File1978-0099							
Da	te	9/22/00 Project Name: Woodland Subdivision					
P	S	A few items are denoted with an asterisk (*), which means they are to be scanned for permanent record on the					
r e	c a	ISYS retrieval system. In some instances, not all entries designated to be scanned are present in the file. There					
s	n	are also documents specific to certain files, not found on the standard list. For this reason, a checklist has been					
e n	n	included.					
ť	e d	Remaining items, (not selected for scanning), will be marked present on the checklist. This index can serve as a quick guide for the contents of each file.					
		Files denoted with (**) are to be located using the ISYS Query System. Planning Clearance will need to be typed					
		in full, as well as other entries such as Ordinances, Resolutions, Board of Appeals, and etc.					
X	X	*Summary Sheet – Table of Contents					
†		Application form

### 27-2.3 FINAL PLAT APPLICATION - City of Grand Junction

WOODLAND SUBDIVISION CITY OF GRAND JUNCTION MESA COUNTY, COLORADO

FILE # g	9=78
ITEM _W	OODLAND SUBDIVISION
MEETING	DATE

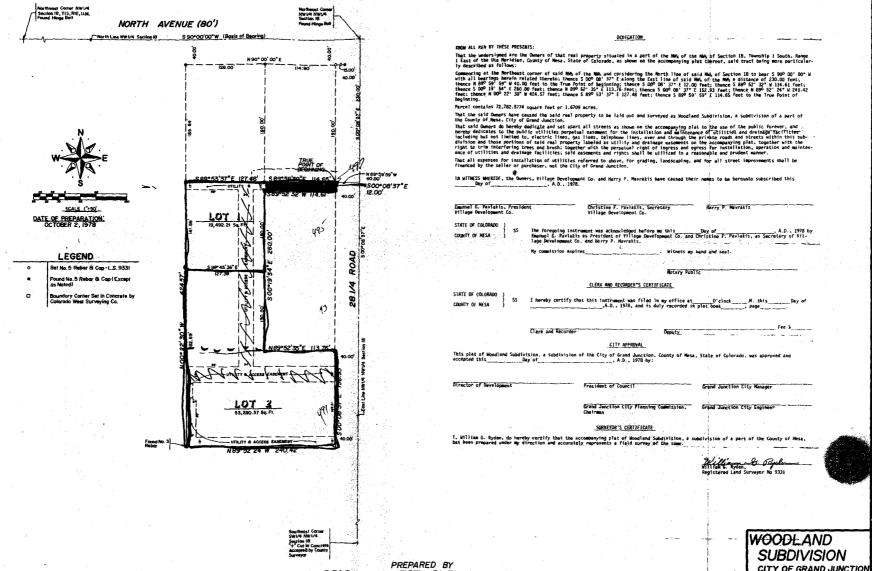
Public Service Electric - The 10' portion of the utility easement on the west side of Lot 2 to be expanded to 15' due to the sewer line going through this easement. Do not object to parking over the easement

Two new hydrants are needed to meet present I.S.O. regulations. The water line size must be 8" diameter instead of the 6" shown on the plat.

Location of hydrants:

1)85' East of the N.W. corner of Lot 1 ) see attached plat

2)140' North of the S.W. corner of Lot 2)

Trash service to lot one cannot be handled through a 12 foot easement. Trash will have to be at the  $28\frac{1}{4}$  Road. 12 foot is not enough room to operate trash truck and turn around in the lot 1, areas is not possible.

The 12 feet easement is too narrow for ingress/egress on North end of development. The south easement of 15 feet is also narrow for traffic movement; as is the 10 feet strip connecting this easement with the 25 feet easement immediately to the north.

- 1)  $28\frac{1}{4}$  Road street improvements are being installed now as part of ST 78 ID.
- 2) Traffic signals are being installed by City at 284 & North Ave.
- 3) Plan doesn't show how site drainage will flow. It must be outletted to  $28\frac{1}{4}$  Road since that is only outlet available in this area.
- 4) Lot 1 has only 12' of frontage on a public street.

Recommend approval based on receipt of drainage plan, staisfactory trash collection points, and review comments (water line sizing, hydrant locations, and easements.)

As a result of that meeting, they agreed that the water service as shown on the original utility composite submitted could be altered as per the attached copy of a revised utility composite. They felt that our project and the surrounding area would be better served with a dead end 8" line and fire hydrant rather than the proposed 6" looped system.
